CONTRACT CHANGE ORDER NO. 322 S1
SHEET 2 OF 2

MARK	DATE	DESCRIPTIONS	BY	CH'D	CCO#
2	08/23/13	MODIFY TRVELER RAIL ANCHORAGE	DT	TH	322S1
1	05/18/09	TRAVELER RAIL MODIFICATIONS	TH	RM	2450
0	07/20/07	RAIL CHANGE AND MISCELLANEOUS DETAILS	TH	RM	24

SAN FRANCISCO OAKLAND BAY BRIDGE
EAST SPAN SEISMIC SAFETY PROJECT
SELF-ANCHORED SUSPENSION BRIDGE
(SUPERSTRUCTURE & TOWER)

SKYWAY TRAVELER RAIL REPLACEMENT DETAILS NO. 4

DETAIL FOR ENLARGED PL 44 HOLES

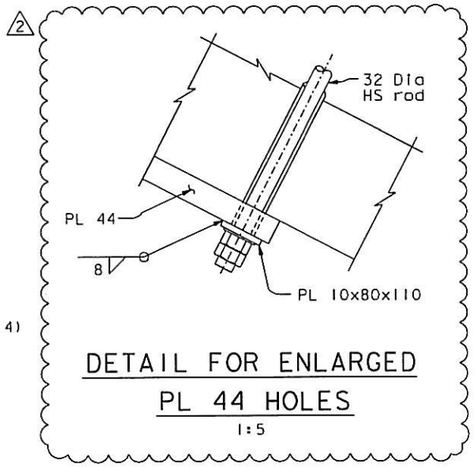
9. If 30 Dia hole in PL 44 is slotted or enlarged, use "Detail for Enlarged PL 44 Holes".
10. Hole to be patched per Caltrans Standard Specifications, using pre-approved products.
